Our ref
PLAN-034183

Proposal: Single storey rear extension, revision to approved planning permission APP/18/00643 & APP/19/01107. (Revised application).

Site: APP/20/00500: - 55 Southbrook Road, Havant, PO9 1RL.

Southern Water MapGuide Browser

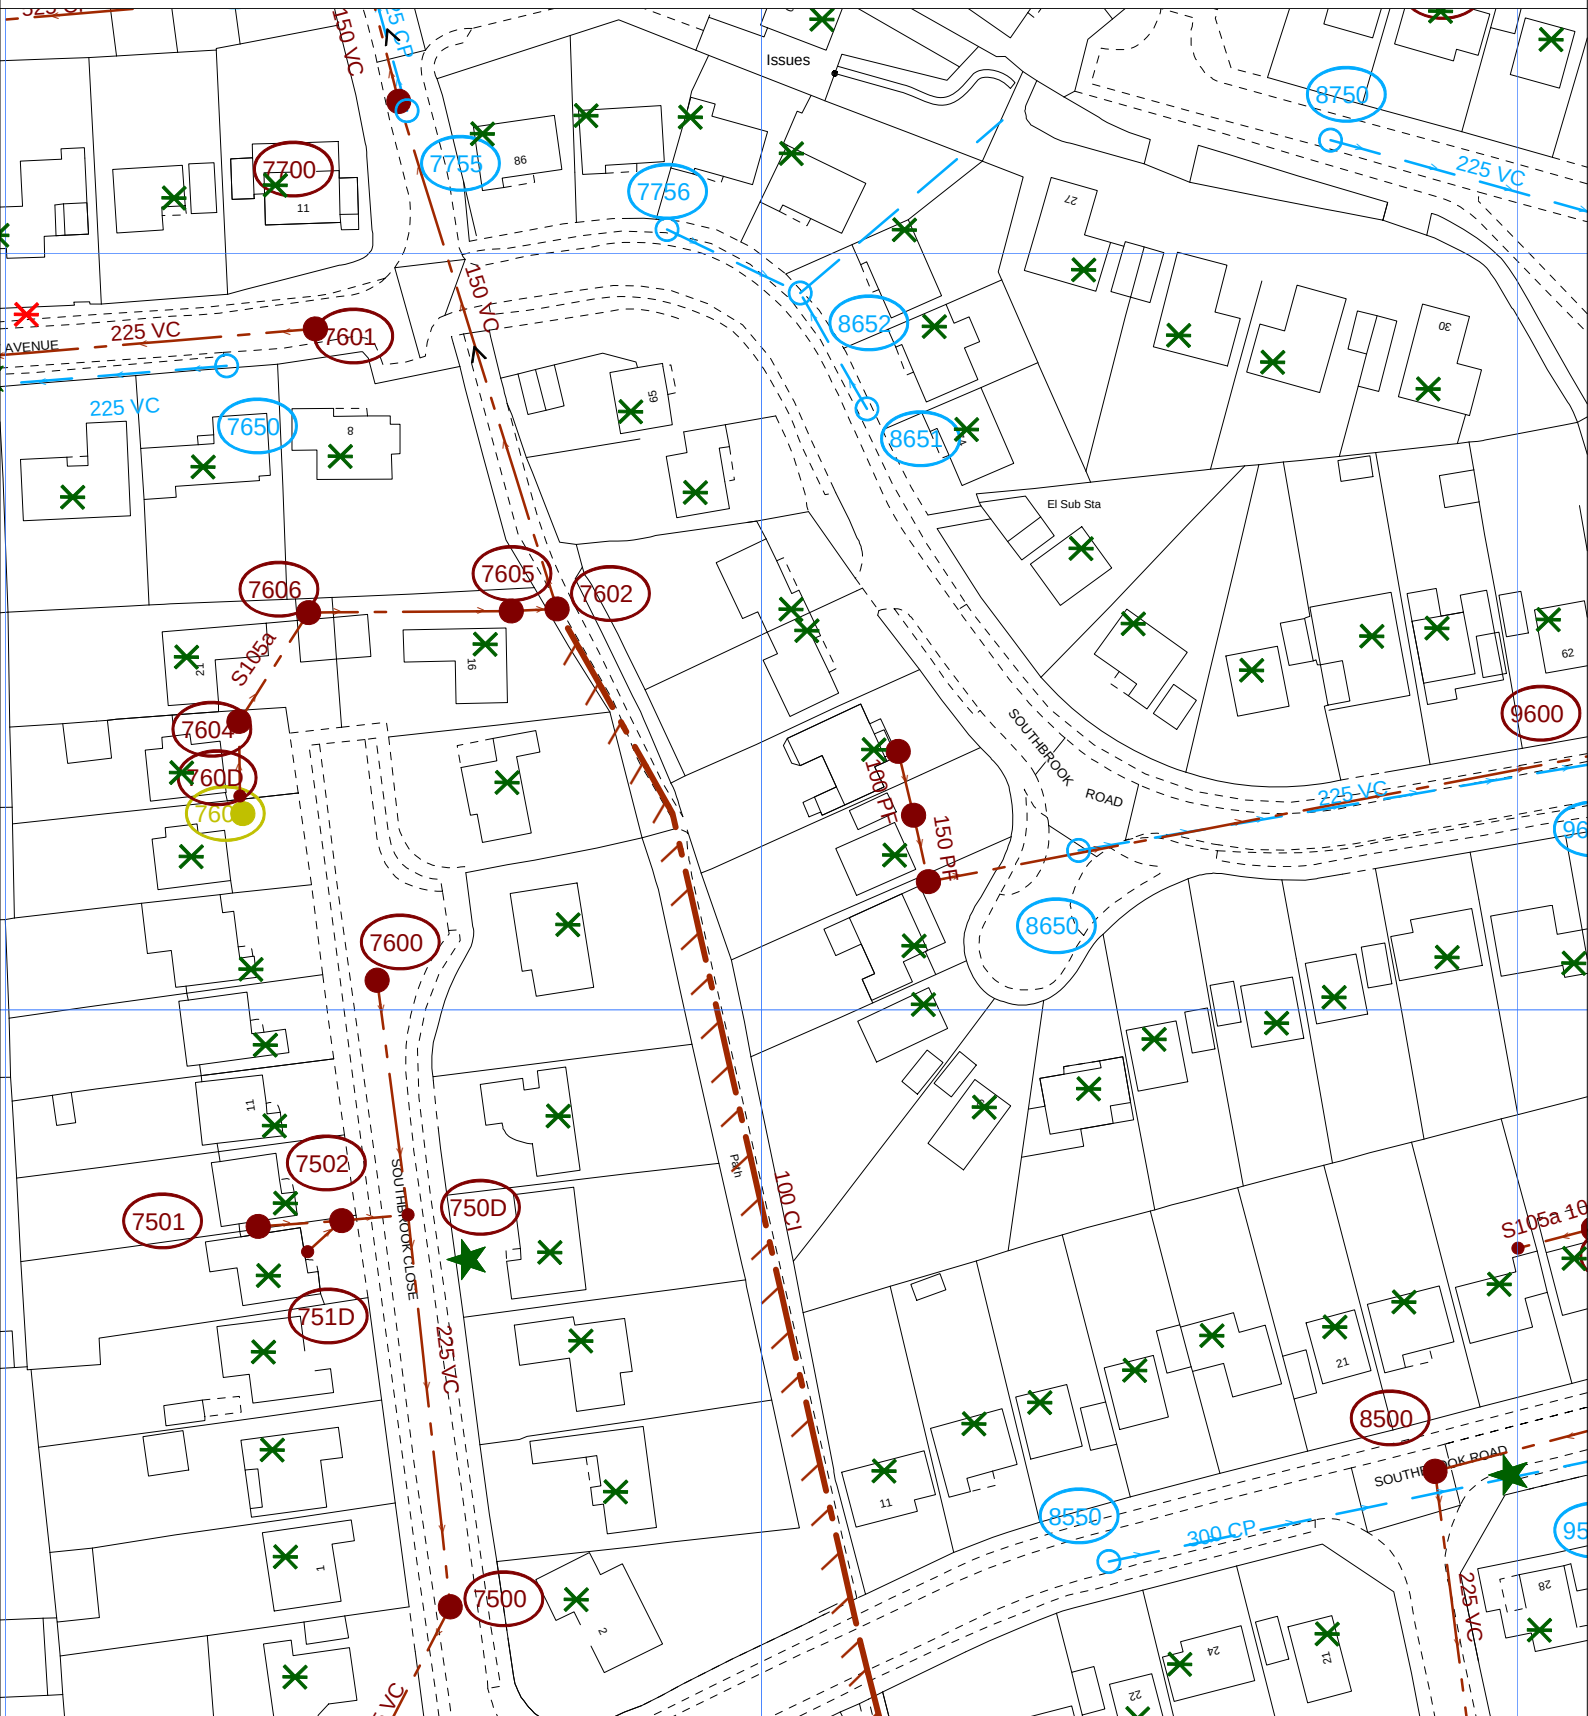
The attached plan shows that the proposed development will lie over an existing public foul sewer which will not be acceptable to Southern Water. The exact position of the public foul sewer must be determined on site by the applicant before the layout of the proposed development is finalised.

- The Public foul sewer requires a clearance of 3 metres on either side of the gravity sewer to protect it from construction works and to allow for future access for maintenance.
- No development or tree planting should be carried out within 3 metres of the external edge of the public gravity sewer without consent from Southern Water.
- No new soakaways should be located within 5 metres of a public sewer.
- All existing infrastructure should be protected during the course of construction works.

It might be possible to divert the sewer, so long as this would result in no unacceptable loss of hydraulic capacity, and the work was carried out at the developer's expense to the satisfaction of Southern Water under the relevant statutory provisions.

Alternatively, the applicant may wish to amend the site layout, or combine a diversion with amendment of the site layout. If the applicant would prefer to advance these options, items above also apply.

In order to protect drainage apparatus, Southern Water requests that if consent is granted, a condition is attached to the planning permission; for example, the developer must advise the local authority (in consultation with Southern Water) of the measures which will be undertaken to divert the public sewers, prior to the commencement of the development.
